SAFETY RECALL BULLETIN

February 2019
D18R7 (FL802)
NHTSA #18V-913 (Non-School Buses)
#18V-914 (School Buses)
Transport Canada #18-719 (Non-School Buses)
#18-720 (School Buses)

Subject: **Detroit™ Axle Steering Arm / Tie Rod Arm Capscrew Inspection**

Figure 1 – Steering Arm and Tie Rod Arm Capscrew Location

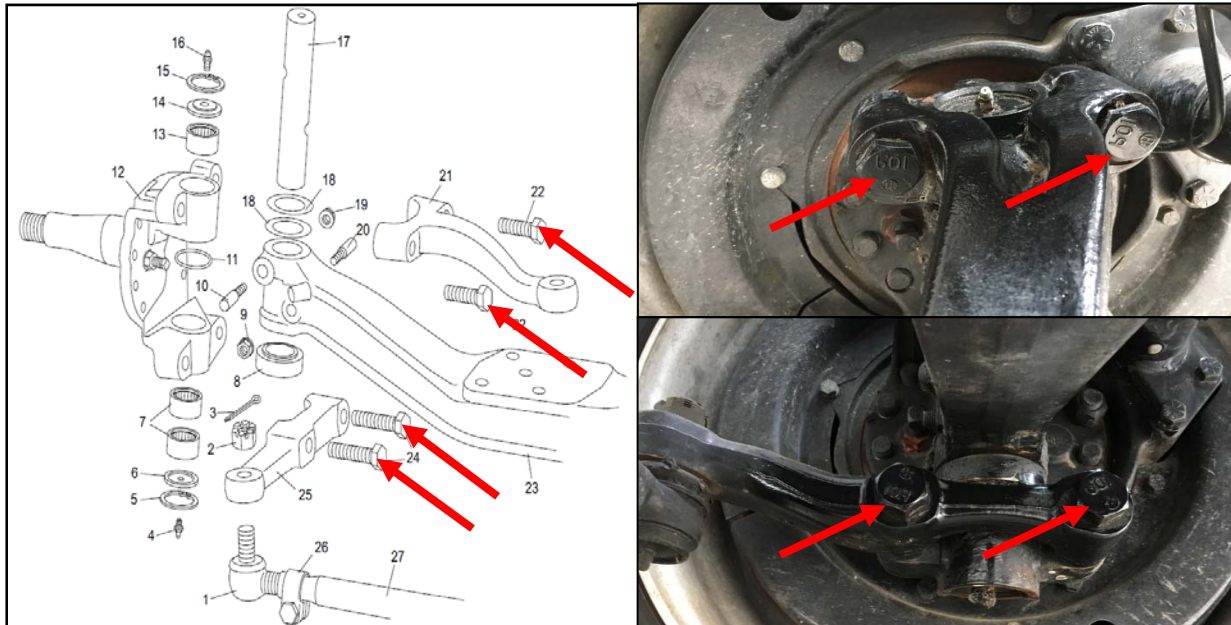
2. Apply the parking brake, turn off the ignition, chock the rear wheels, and perform any other applicable safety steps.
3. Using a suitable torque wrench, check the torque on the two steering arm capscrews as well as the forward tie rod capscrew on the driver's side and the rear tie rod capscrew on the passenger's side. See Figure 1.
 - a. For Model 2 and Model 3 axles with a M20 capscrew, the torque should be checked at 525 N·m (390 lb·ft).
 - b. For Model 5 axles with a M24 capscrew, the torque should be checked at 850 N·m (630 lb·ft).

4. Are the capscrews at the correct torque?
 - a. Yes; proceed to step 5 to check the other capscrews.
 - b. No; mark which capscrews are at low torque before proceeding to step 5 to check the rest of the capscrews. Any capscrews that are below the correct torque will need to be repaired following the instructions starting in step 9.

Figure 3 – Dent at the Loose Joint

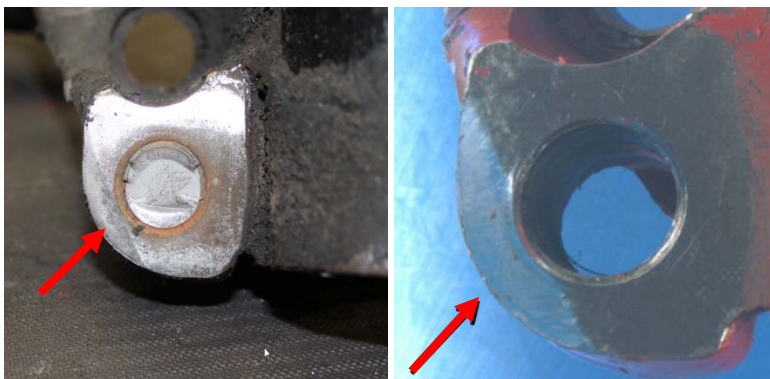
9. Remove the two capscrews from the steering or tie rod arm where the low torque capscrew(s) was identified, and remove the steering or tie rod arm. **Reference** section “Dissassembly of the Steering Knuckle” in the Front Axles chapter of the *Detroit Axles Manual* (DDC-SVC-MAN-0141).
10. Inspect the joint surface between the steering or tie rod arm and steering knuckle for signs of fretting, dents, or other damage from the loose capscrew(s). See Figure 2 and 3 for examples of damaged parts, and Figure 4 for an example of a new part.

11. Are the joint surfaces of either the steering or tie rod arm or steering knuckle damaged?
 - a. Yes; proceed to step 12 to replace the knuckle and the arm.
 - b. No; proceed to step 14 to replace the capscrews only.
12. **Remove the steering or tie rod arm and steering knuckle. Reference** section “Dissassembly of the Steering Knuckle” in the Front Axles chapter of the *Detroit Axles Manual* (DDC-SVC-MAN-0141).
13. **Install a new steering or tie rod arm and new steering knuckle. Reference** section “Assembly of the Steering Knuckle” in the Front Axles chapter of the *Detroit Axles Manual* (DDC-SVC-MAN-0141).
14. **Install two new steering or tie rod arm capscrews. Reference** section “Assembly of the Steering Knuckle” in the Front Axles chapter of the *Detroit Axles Manual* (DDC-SVC-MAN-0141).
15. Repairs are complete.
